TB 1-1520-248-20-67

### REPAIR/RE-ROUTING OF COMPRESSOR INLET TEMPERATURE (CIT)

SENSOR HARNESS 406-075-625-139

FOR OH-58D AIRCRAFT

Figure 1. Transmission Vent Tube View Looking Down

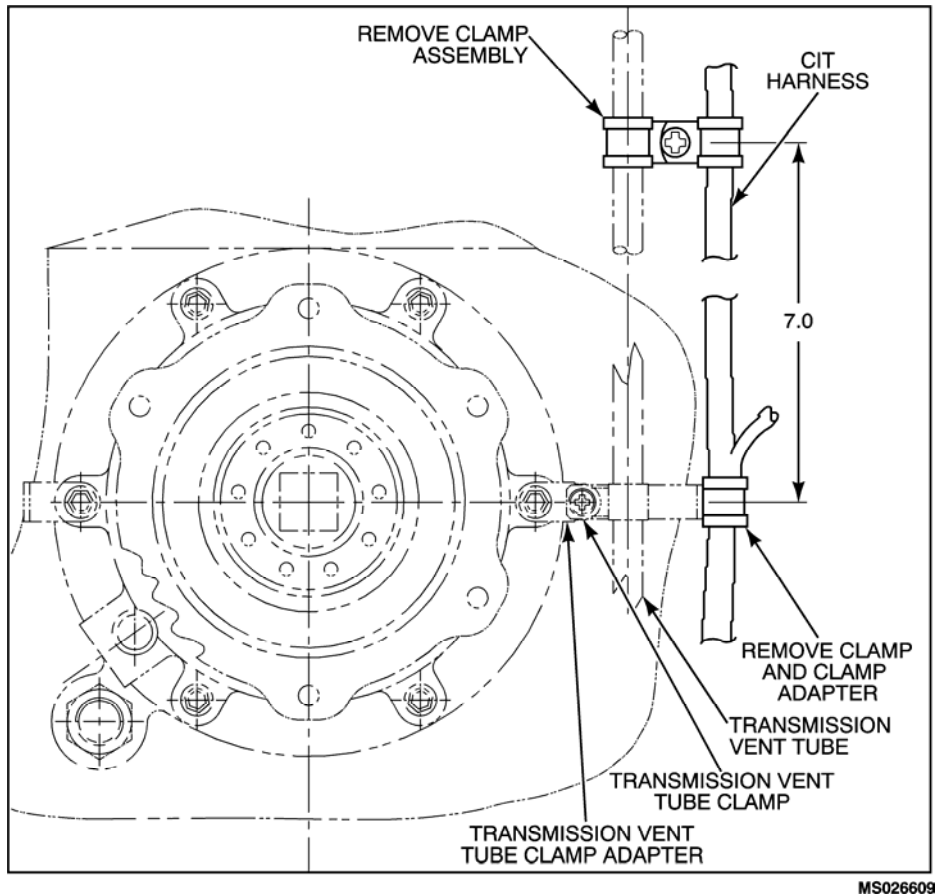
- 1) Gain access to work area and perform re-routing of CIT harness.
  - a) Remove forward fairing per IETM TM 1-1520-248-23, task 2-2-47.
  - b) Disconnect the CIT sensor connector plug to allow the CIT and NR sensor wiring harness to be re-routed together.
  - c) Disconnect the transmission NR sensor connector plug to allow the CIT and NR sensor wiring harness to be re-routed together.
  - d) Remove clamps securing CIT sensor harness to the transmission vent tube. These clamps will not be re-installed. Refer to figure 1.

- e) Remove the CIT sensor harness clamp adapter from the transmission vent tube clamp adapter attached to the transmission input quill housing. Refer to figure 1.

- f) Re-install the transmission vent tube clamp to the clamp adapter attached to the transmission input quill housing. Refer to figure 1.
- g) Remove pan head screw from the bottom side of the induction fairing, just above the aft end of transmission right hand pylon beam assembly.

**Figure 3. Harness Routing**

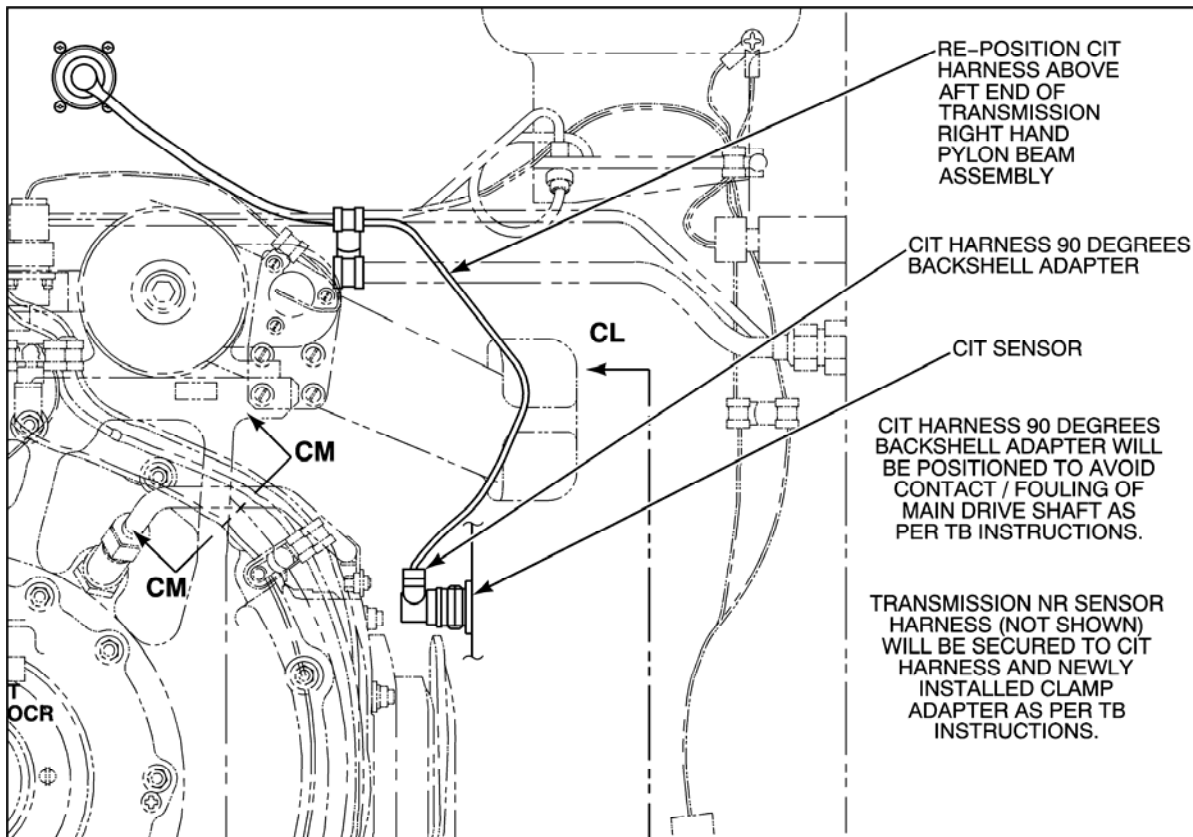
- h) Attach the long angled bracket NSN 5340-00-158-4188 to this location. The long leg of the bracket is installed at 9 o'clock angle in relation to the aircraft, with the short leg of the bracket inboard and down. Secure the bracket to the bottom side of the induction fairing using machine screw NSN 5305-00-944-5929. Refer to figure 3.

- l) Secure both the CIT and NR sensor wiring harnesses together using clamp NSN 5340-00-200-8560 and attaching to short leg of long angled bracket. Refer to figure 3. Hardware to secure clamp is one each of the following:

**Figure 2. Harness Routing View Looking Down**

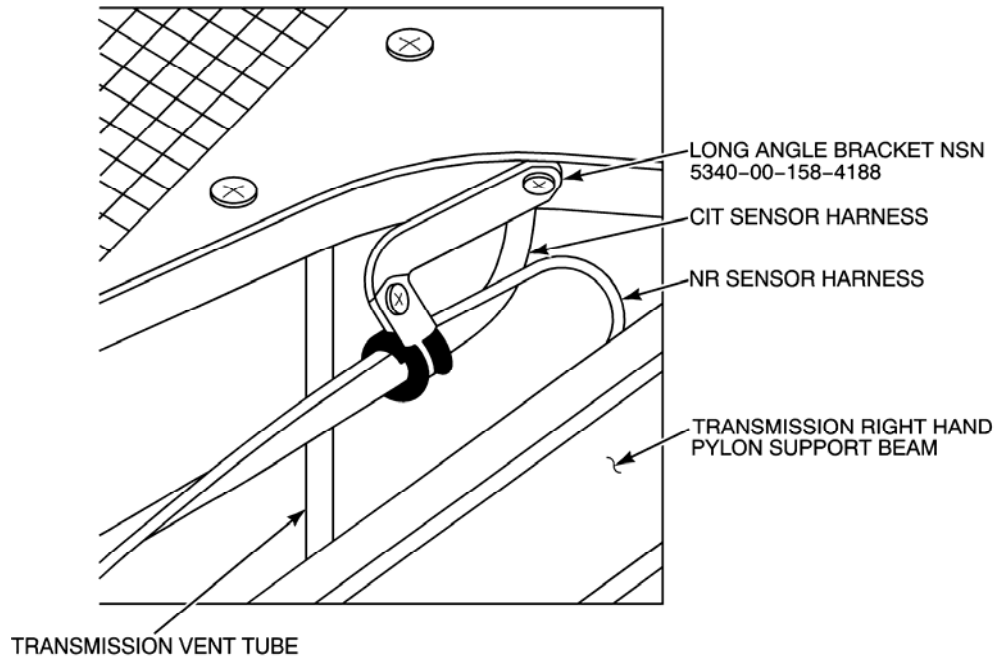
- j) Re-install right side EBF IAW IETM TM 1-1520-248-23, Task 4-2-18.
- k) Re-route CIT and NR sensor wiring harnesses above the aft end of the transmission right hand pylon beam assembly and restraint spring assembly. Refer to figures 2 and 3.

Figure 4. CIT Harness Schematic

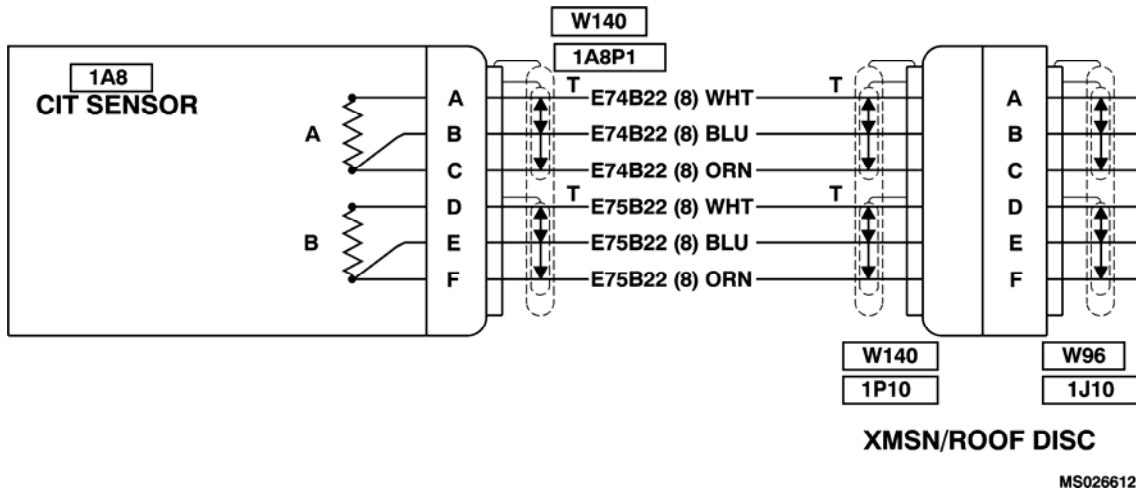
- o) Perform MOC.
- p) Re-install forward fairing IAW IETM TM 1-1520-248-23, task 2-2-47 and return to service.
- c. Harness Repair/Manufacture.
- 1) If harness damage is noted, repair or replace harness assembly per guidelines set forth in TM 1-1500-204-23-4, Electrical and Avionics Maintenance Practices Manual. Refer to figure 4, Electrical Schematic for details on harness repair.
